MINOR AMENDMENTS TO FENESTRATION

DO NOT SCALE THIS DRAWING WRITTEN DIMENSIONS ONLY TO BE USED ALL DIMENSIONS ARE IN MILLIMETRES ALL DIMENSIONS TO BE VERIFIED ON SITE ANY INCONSISTENCIES TO BE REPORTED TO THE ARCHITECT IMMEDIATELY	Job No 7155		p-ad 192D Compden Hill Road, Notting Hill Gate, London, W8 7TH		t: 0208-4590172 e: info@p-ad.co.uk				
	FOR CONSTRUCTION								
	87-93 Kingsgate Road, London, NW6 4LA		Title		TYPICAL WINDOW DETAILS				
			Drawn by SG		Scale 1:20 @ A3			Number 7155/C 2.4

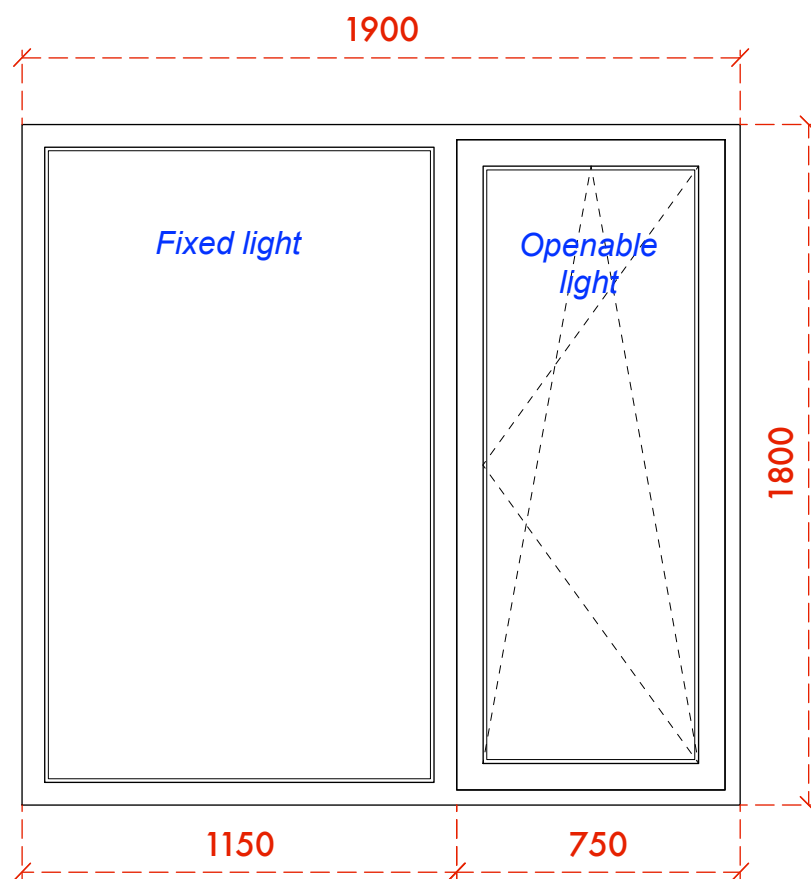
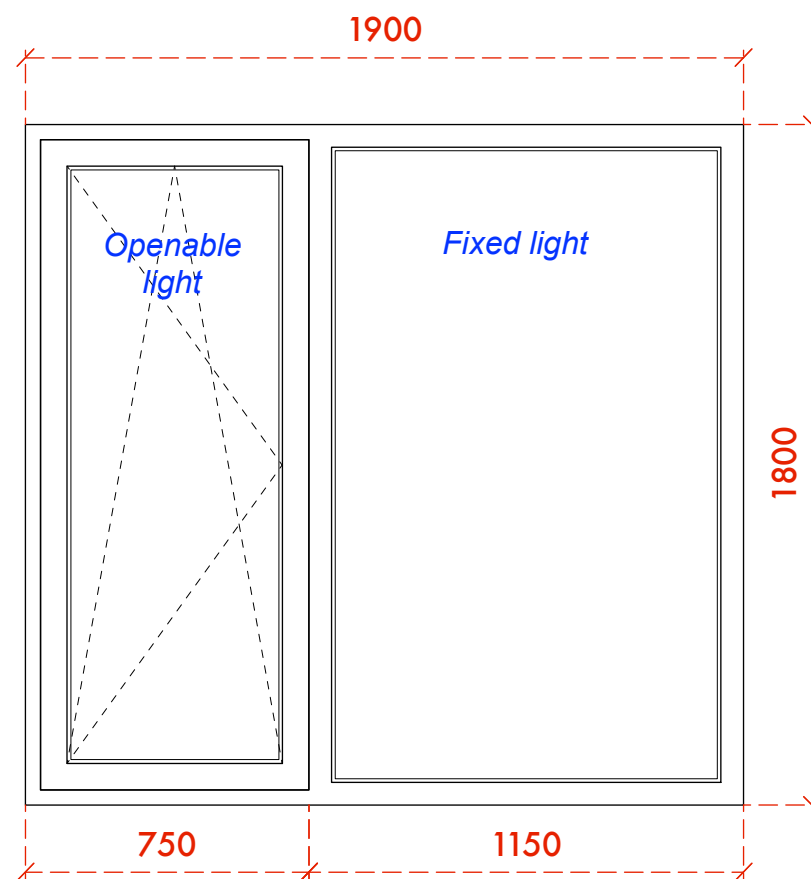
It proved impossible to find a manufacturer for the previous design of windows where the entire window was a single opening light. It was also advised that such a window would not achieve the required ventilation in the bedrooms and would not meet the U-Value requirements.

As such minor amendments to the fenestration are proposed to achieve both the ventilation requirement and thermal performance.

An openable light is introduced into each window. It would be both hinged and tilt opening to achieve good ventilation and has been designed to balance the elevation - see below.

The windows are to be a composite construction ie timber frames with aluminium face. The aluminium is to be powder coated in RAL colour to match the front door and zinc cladding.
